**Planning Board Agenda
July 27th, 2020
7:00pm**

TO: Village of Spring Valley Planning Board
FROM: Michael D. Kauker, PP, AICP
Principal
DATE: July 24, 2020
SUBJECT: **93 Union Road**
Review # 1

TO: Village of Spring Valley Planning Board
FROM: Michael D. Kauker, PP, AICP
Principal
DATE: July 20, 2020
SUBJECT: **22 South Main Street**

TO: Village of Spring Valley Planning Board
FROM: Michael D. Kauker, PP, AICP
Principal
DATE: July 20, 2020
SUBJECT: **131 Bethune Boulevard**
Review # 5

A-1

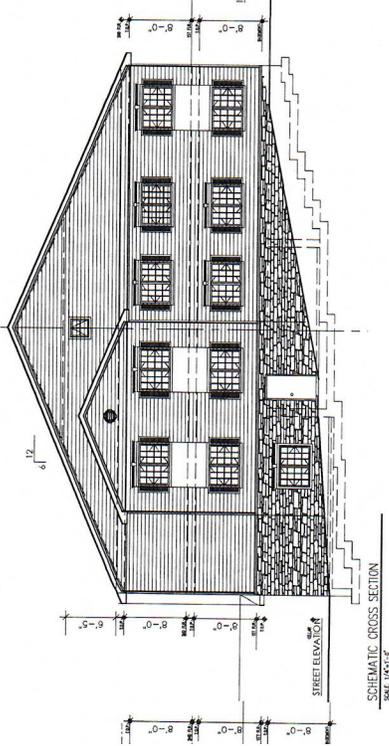
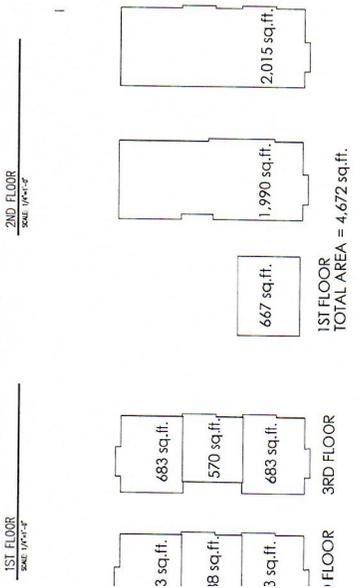
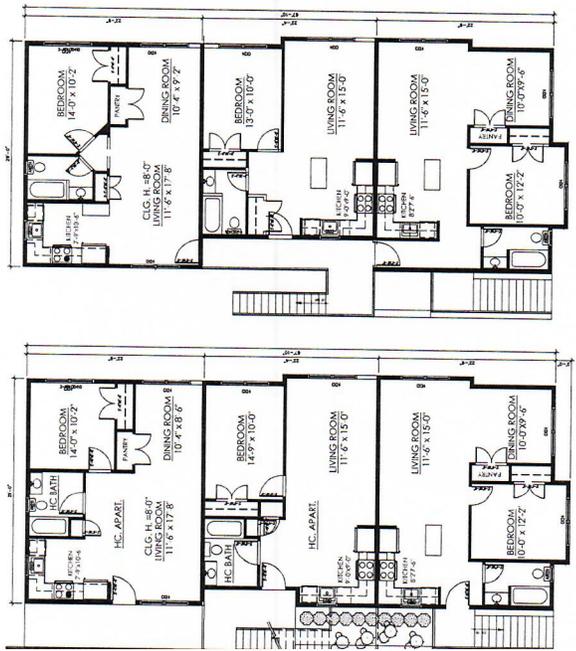
None provided. The applicant should provide architectural plans.

Michael Kauker memo dated July 2, 2020. Page #2- General comments.

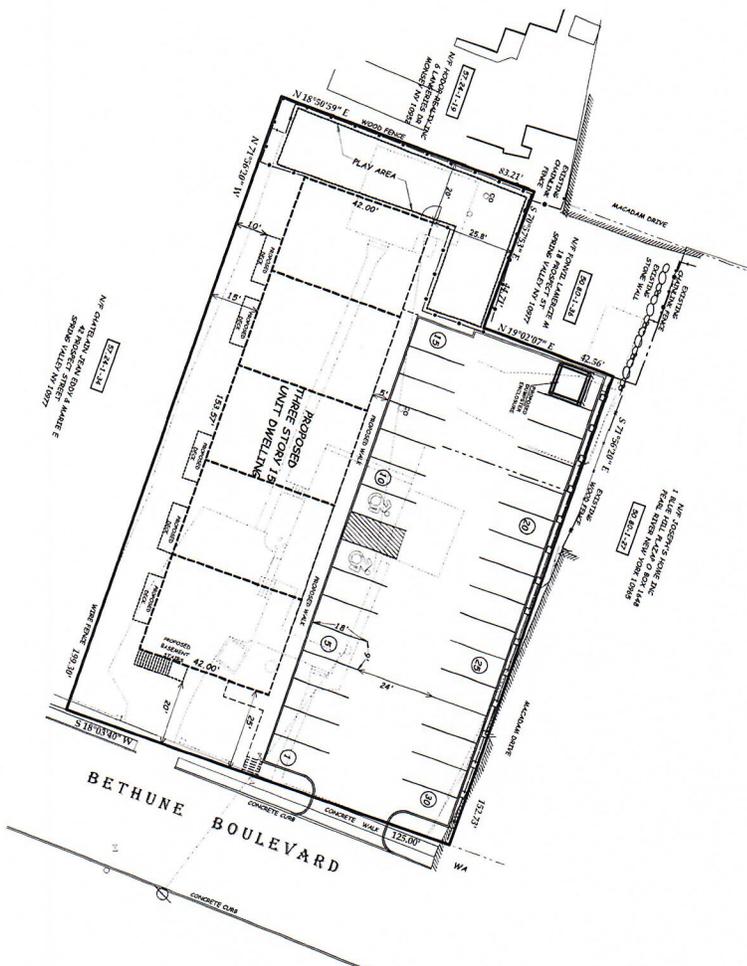
1. There are some features shown on the architects plans that are not shown on the site development plan (such as concrete pads and decks). The applicant should ensure that both plans are consistent. Plans should be revised accordingly. **The site development plan has been amended but still is not consistent with the architectural plans. For example, the architectural plans show stairs leading to the basement on the southerly rear side of the building, where the site plan shows the stairs on the easterly front side of building. The entry to the building on the easterly front side of building is show in the middle of building on architectural plans and the site development plan does not show this entrance.**

2. We would recommend that the applicant provide lights that are more residential in their appearance. **Narrative indicates the lights will be provided by the applicant, but the site development plan has not been amended to show the residential type lighting fixture. This should be provided.**

3. We would recommend that additional landscaping be provided in the front of the building and continuing into the southerly side yard to a point at least to the second block of units. Recommended plantings consist of ornamental trees and shrubs. The purpose is to enhance the view from the public street. **The landscaping has been extended along the entirety of the front property line.**

4. The architectural plans show doors to the basement. The applicant shall provide testimony regarding the use of the basement. **The applicant indicates the basement will only be used for utilities, equipment and storage. A note should be included on the plan.**

5. The architectural plans show dormers on the roof/attic area and it appears that this area could be useable. The applicant shall provide testimony regarding the ceiling height of the attic area and of this area will be used for anything. **The applicant indicates that the dormers are for aesthetics only and that there will be no access to the attic.**

- 1) Decks and stairs to basement shown on site plan
- 2) Applicant to provide residential fixtures
- 3) Additional Landscaping provided – Maple trees & bushes added to front yard and on southerly side yard.
- 4) Basement to be used primarily for utilities, equipment and storage.
- 5) The dormers are just for ascetics no access to attic.
